Amendment, Permit # B23001392

I am requesting to amend Permit # B23001392 at

11915 MEADOW VISTA WAY CLARKSVILLE, MD 21029 to

① Roof Framing Plan
 1/4" = 1'-0"

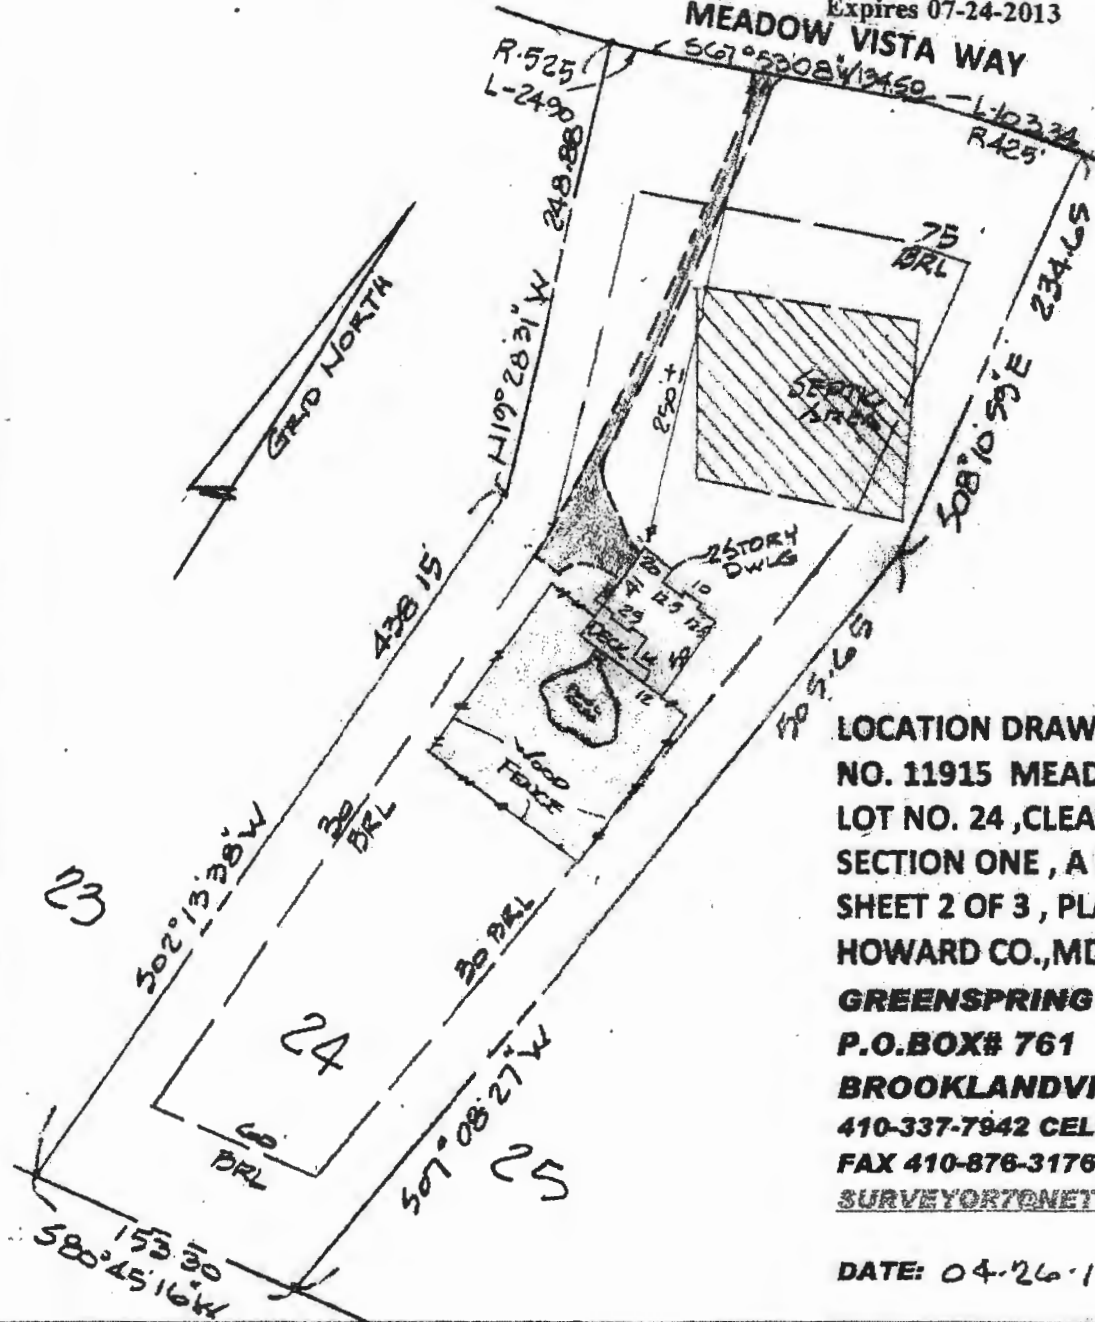
- Original application rafters were measured wrong. Actual rafters span measurement is 17'6" (as shown on the attached Roof framing plan).
- New skylights were also added with additional framing around skylight
